Report to the Future Melbourne (Planning) Committee

Melbourne Metro Rail Project – City of Melbourne’s submission to the Environmental Effects Statement

5 July 2016

Figure 37 – City North Station Concept Design (Melbourne Metro Rail Project EES – Map Book)

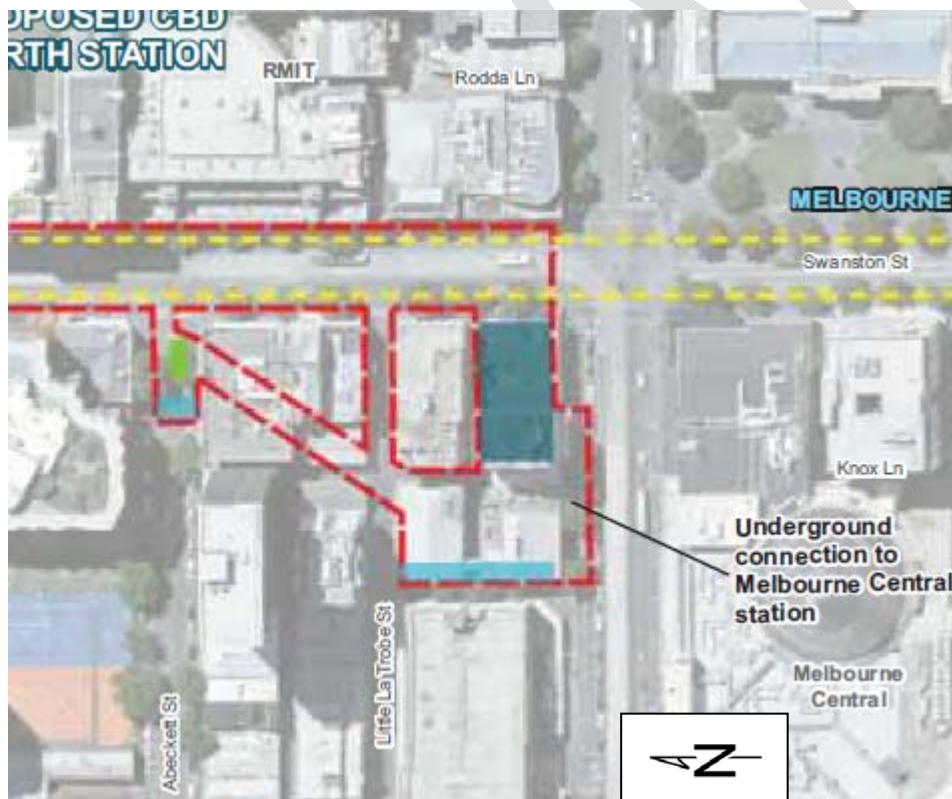
The Concept Design shows the location of an emergency access and ventilation structures to be located in the centre of the A’Beckett Street. This would require the closure of the street to east of the Stewart Street alignment (see Figure 37 below).

Figure 47 – City South Station proposed construction routes (Melbourne Metro Rail Project EES – Map Book)

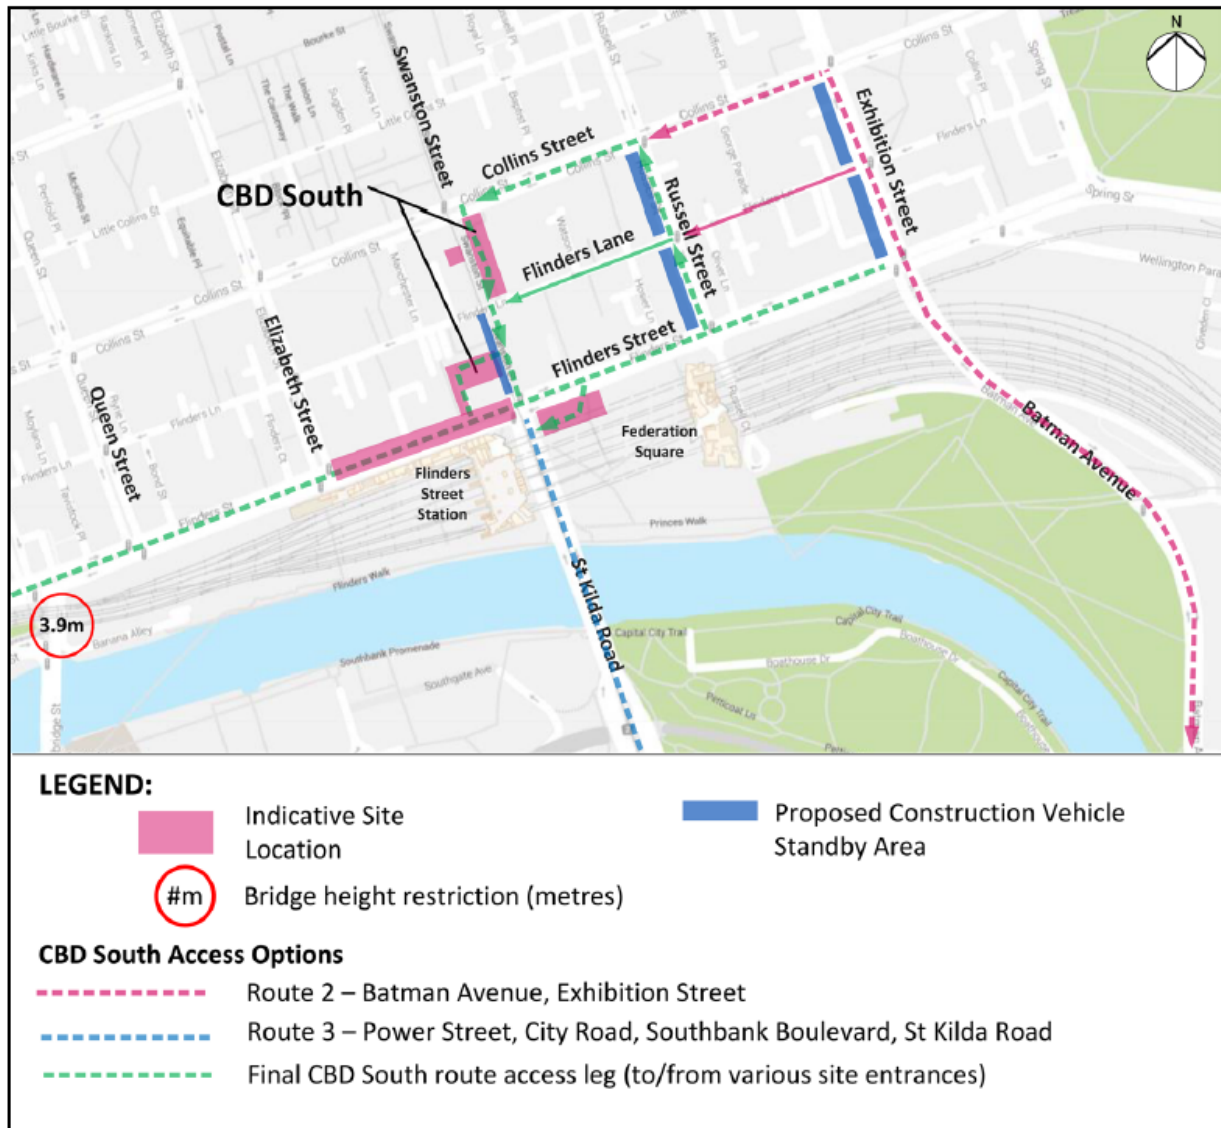
The proposed truck stand by areas shown in the above Figure 47 are likely to impact significantly on traffic movements on these streets as well as the servicing of adjacent properties and are therefore unacceptable. The City of Melbourne would like to work with the MMRA to identify alternatives to this. For example, the City of Melbourne would encourage exploration of the potential to use existing Vic Track owned land to the south of existing rail lines and that has access to the Exhibition Street extension as highlighted below. This could accommodate storage space for trucks.

Figure 53 – Detail for Domain Station Concept Design (Melbourne Metro Rail Project EES – Map Book)

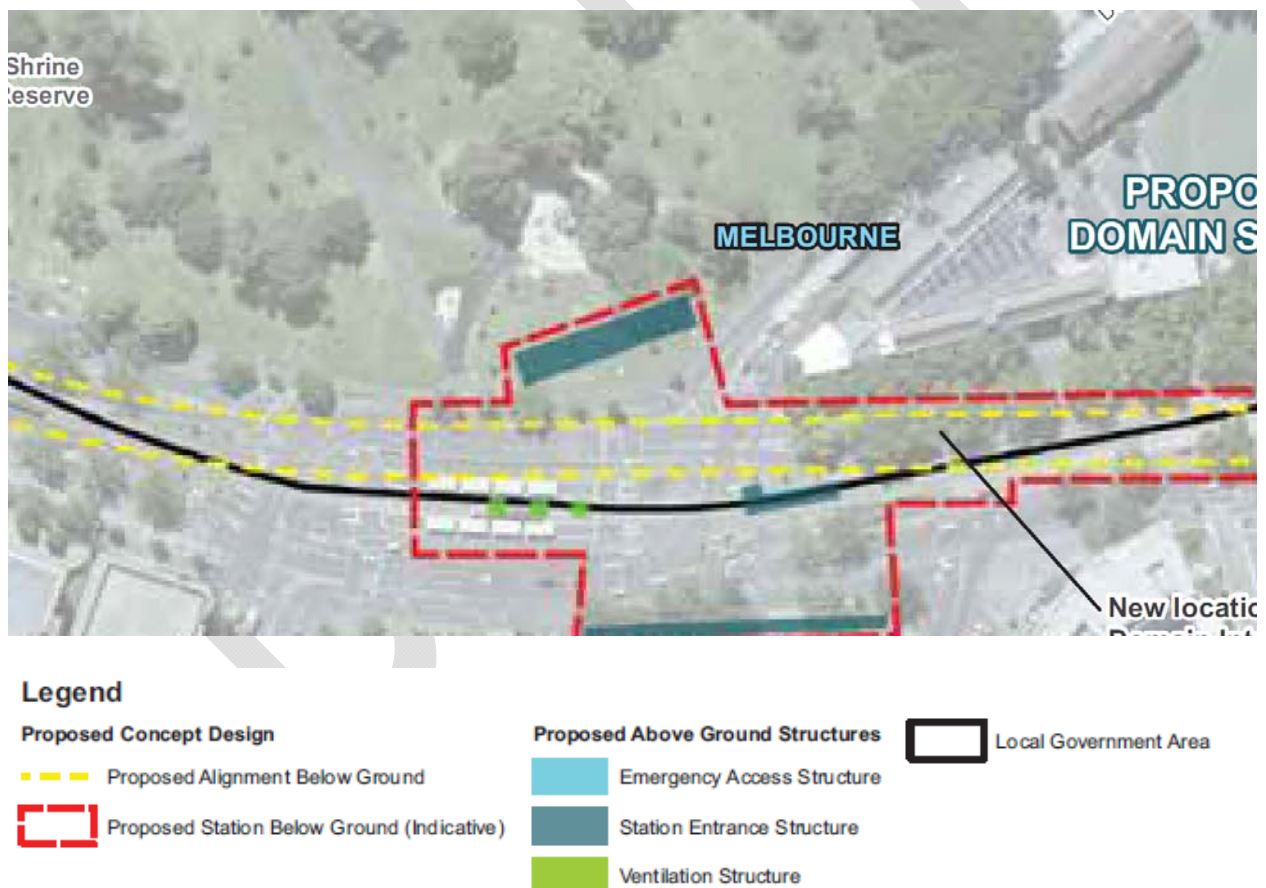
The siting, design and scale of the proposed entry needs to be modified to reflect projected use and to reduce adverse visual impacts. This might be achieved by co-location of structures and siting the entrance further to the east on Domain Road.

A station entrance is proposed to be located on the north-east corner of St Kilda and Domain Roads. The entrance is shown as being located within the Shrine Reserve adjacent to the MacPherson Robertson Fountain (see Figure 53 below).

Figure 56 – Construction are for Domain Station Precinct Concept Design (Melbourne Metro Rail Project EES – Map Book)

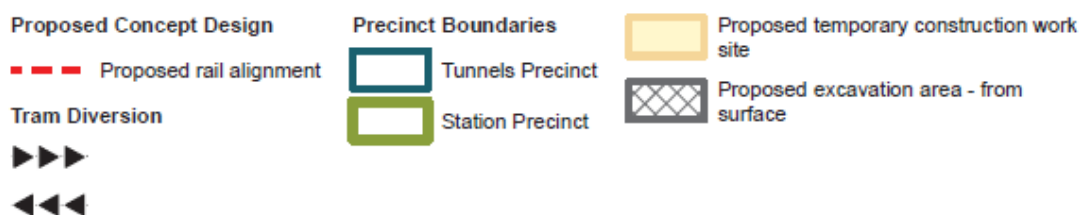
The EES shows Edmond Herring Oval as being a construction lay-down area. The Oval is part of the land that is included on the Victorian Heritage Register (VHR H2304 for the Domain Parklands, Kings Domain South). Figure 56 below shows the part of the oval to be used for this purpose.

Figure 61 – CBD South Station Concept Design and relationship with Melbourne Town Hall (Melbourne Metro Rail Project EES – Map Book)

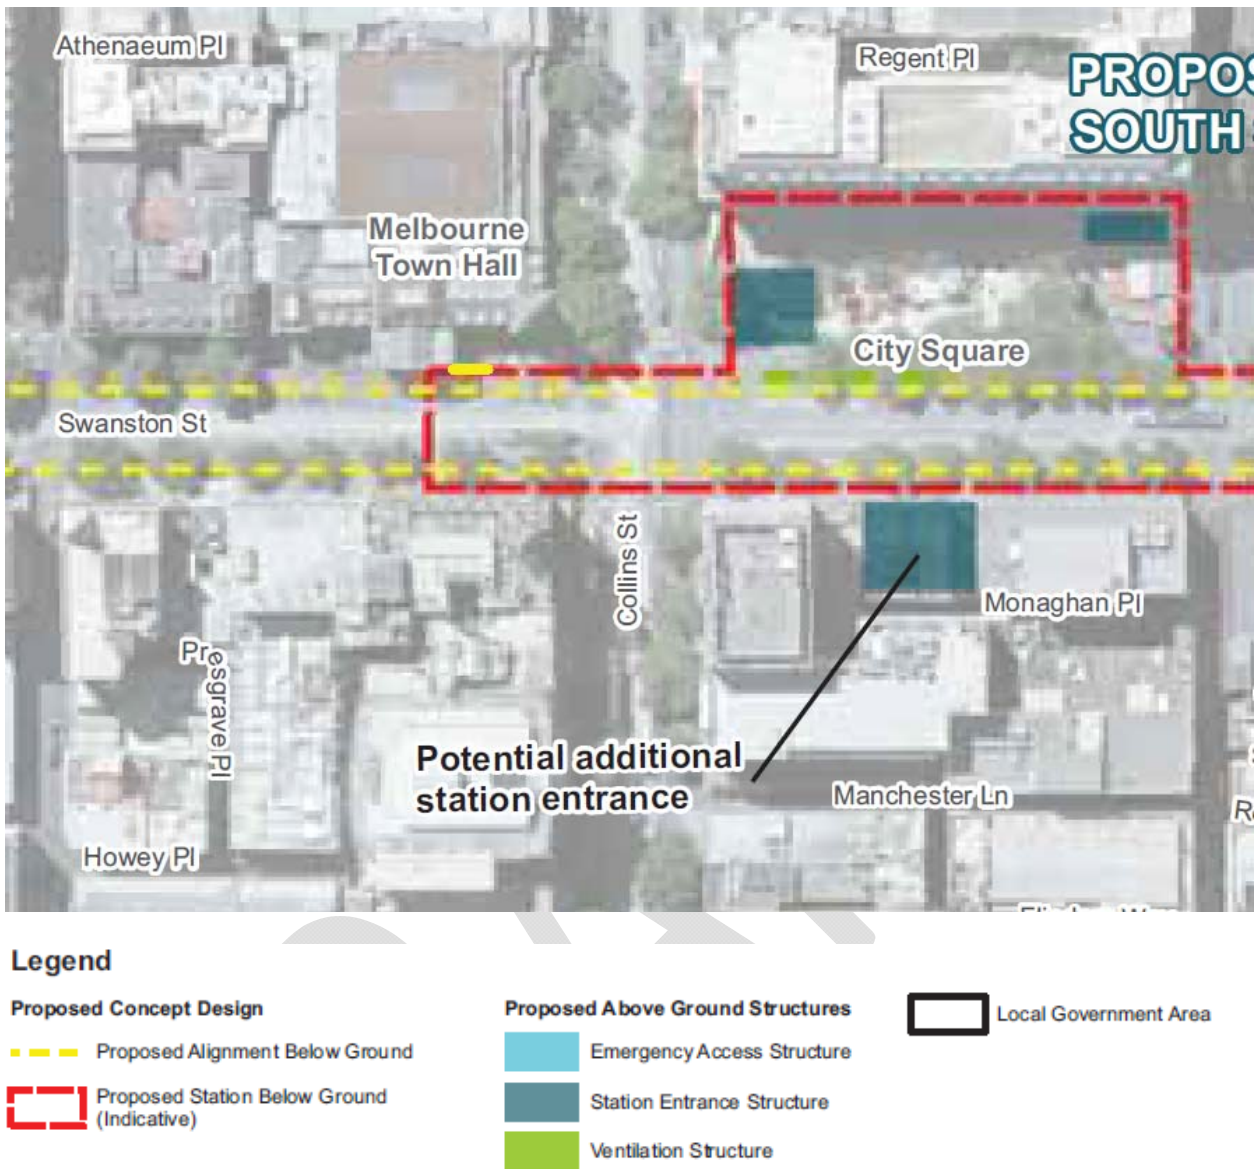
While excavation work is not proposed within close proximity to this building (the closest excavation being at the City Square), the tunnel alignment and part of the proposed station box under Swanston Street is directly adjacent to, and partially, below this building (see Figure 61 below).
